RECALL BULLETIN 05V-261

DATE: SEPTEMBER 12, 2005
 MODEL YEAR: 2002- Certain Early Production 2005 Model Years
 CHASSIS MODEL: UD1200/UD 1300/UD1400
 BULLETIN NUMBER: SC-261
FILE IN THE ELECTRICAL SECTION OF THE TECHNICAL BULLETIN BINDER

**VOLUNTARY SAFETY RECALL CAMPAIGN NUMBER 05V-261:
 BATTERY CABLE REPLACEMENT**

Figure B2 (2005 MY) With retaining clamp on Transmission mount

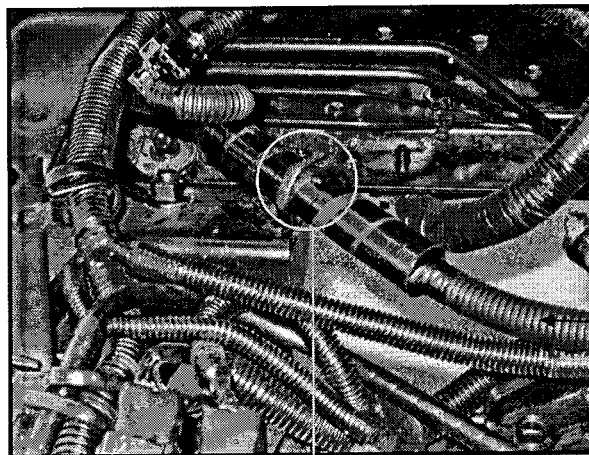
STEP 3B (Metal retaining clip in place)
Install, route and secure the battery cable through the welded metal retaining clamp as shown in Figure B2.

Figure B1 (2002-2004 MY) Without retaining clamp on Transmission mount, use a Tie Strap PN 01552-00043

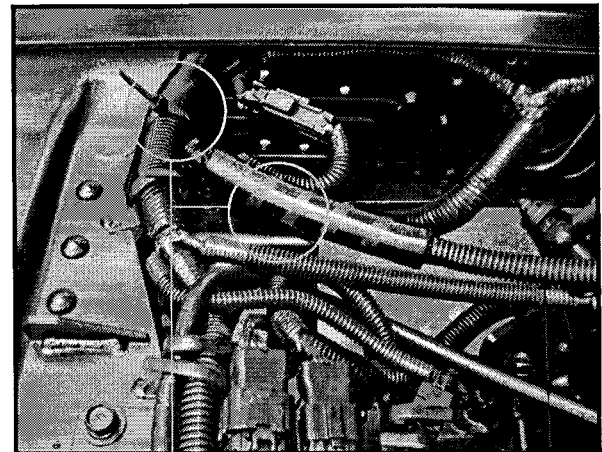
Step 3A (Metal retaining ring missing or broken)
Install, route and secure the battery cable to the chassis harness as shown in Figure B1 using a tie strap PN 01552-00043.

Figure C

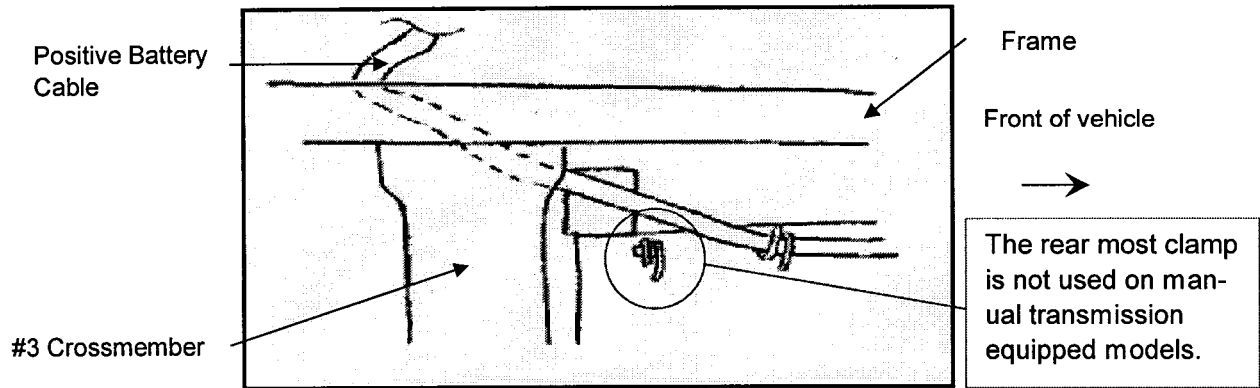
On Manual Transmission Models: Do not use the rear most retaining clip on the transmission shift cover securing the battery cable on manual transmission, see illustration Figure C for details.

Figure E

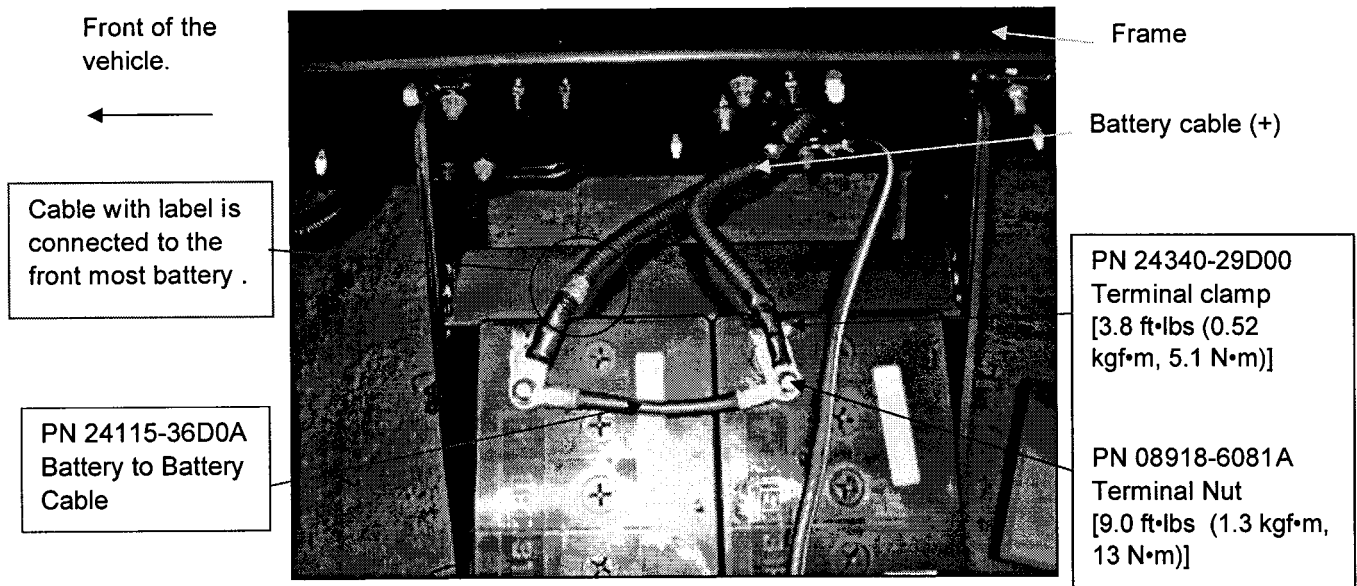
1. Add battery terminal clamp PN 24340-29D00 to the rear most battery's positive post.
2. Using battery– to–battery cable PN 24115-36D0A connect both positive terminals.
3. Attach the alternator feed cable to the rear most battery terminal clamp using nut PN 08918-6081A and torque to specifications under References on page 7.
4. Attach the battery cable affixed with a label around the conduit to the front most battery's positive terminal as shown in Figure E.
5. Tighten all connections to the torque specifications under References on page 7.
